PanoVu Firmware

Version: V5.3.16

Release Note

• This firmware is for DS-2DP1636-D.

Figure 1 Panoramic view

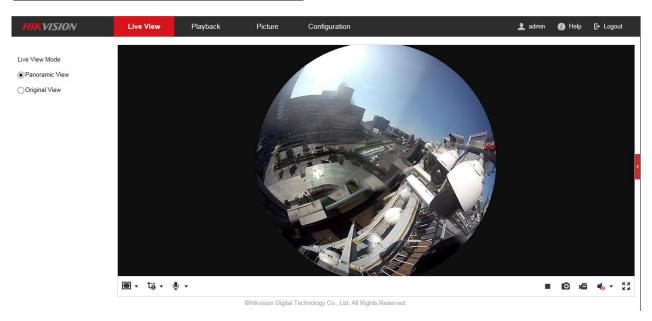
Support panoramic view and original view model. Web component support TCP and HTTP live
 view. Client support TCP and RTSP over TCP.
